MINERALS PROGRAM INSPECTION REPORT
PHONE: (303) 866-3567

| MINE NAME: Cresson Project | MINE/PROSPECTING ID#: M-1980-244 | MINERAL: Gold | COUNTY: Teller |
| INSPECTION TYPE: Monitoring | INSPECTOR(S): Timothy A. Cazier | INSP. DATE: July 23, 2019 | INSP. TIME: 09:00 |

Photo 2. Small amount of sludge observed in Process Ore Thickener secondary containment area.

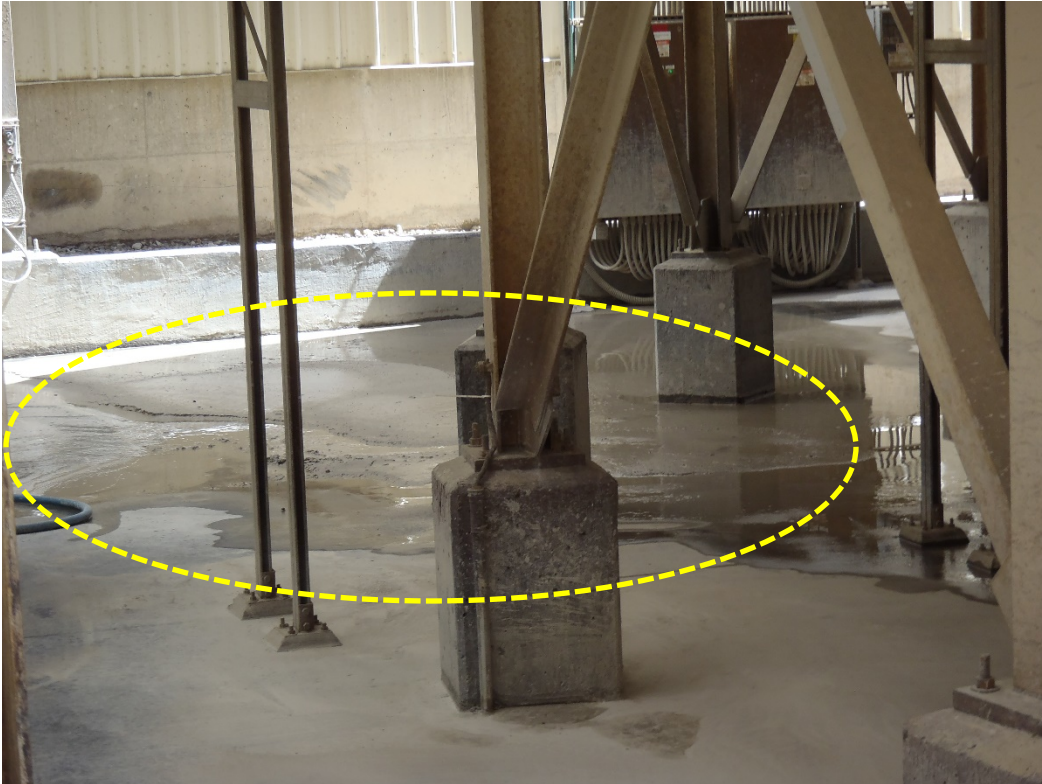
High Grade Mill: Mr. Bills, Messrs. Charles Bissue and Dave Rigsby accompanied the DRMS on the mill exterior walk-around inspection. The purpose was to perform a visual inspection for leaks, spills and secondary containment problems. Both the east and west sides of the mill exterior were inspected, as well as the area around the concentrate storage facility (Con Barn). No significant problems were observed. Small amounts of rain water were observed in the secondary containment area of the Neutral pH Process Water Tank (See **Photo 1**) and a small amount of sludge was observed in the Process Ore Thickener secondary containment area (See **Photo 2**). The vat leach circuit on the west side of the HGM continued to be offline (since February of 2018). The silo (See **Photo 3**) on the SE corner of the mill was being prepared to move to its new location just south of the Squaw Gulch Overburden Storage Facility as allowed by the DRMS with the approval of TR-114.
